AGENDA ITEM 2 - 228 BROAD STREET

PROJECT DESCRIPTION: The applicant is requesting to combine master and preliminary plan approval to construct a five story mixed-use building with 80 dwelling units and commercial space on the ground floor. Design waivers from window sill height and ground floor transparency are requested. A waiver from submission of state approvals at the preliminary plan stage is

CASE NO./ **PROJECT TYPE:** 22-041 MA

PROJECT LOCATION: 228 Broad Street

Aerial view of the site North building elevation

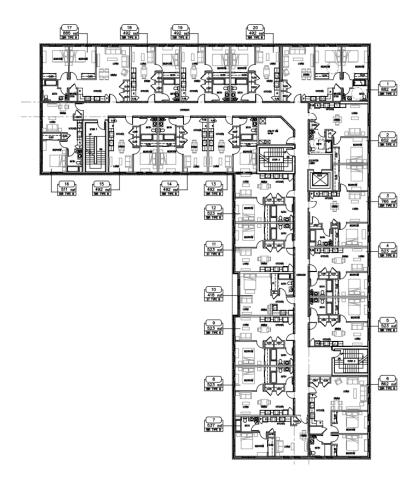
The ground floor frontage will have some glazing with a glass main entrance on the north elevation and windows on the front. However, some of the windows will be opaque, resulting in approximately 29% of transparency, less than the 50% required. The fenestration on the upper stories will exceed the 25% requirement. The ordinance requires that the bottom of the window frame shall not be located over two feet from grade, but a sill height of approximately 4' is proposed. The applicant is seeking design waivers from the transparency and sill height requirements.

The applicant is seeking two design waivers, from total transparency on the ground floor façade and from the window sill height. Per the applicant, these conditions are necessary due to the nature of the ground floor business, which is intended to be a medical office. The reduced transparency and sill height are being proposed to allow for a design that is sympathetic to the privacy requirements of the business. Based on the elevations, the design is not expected to detract from the character of the commercial corridor as it retains the appearance of a storefront, which is encouraged. The DPD would not object to granting these waivers as they are required for the operation of the medical office.

The CPC should grant the design waivers for transparency and sill height finding that the use of the first floor requires these waivers and that design of the building meets the intent of the ordinance.
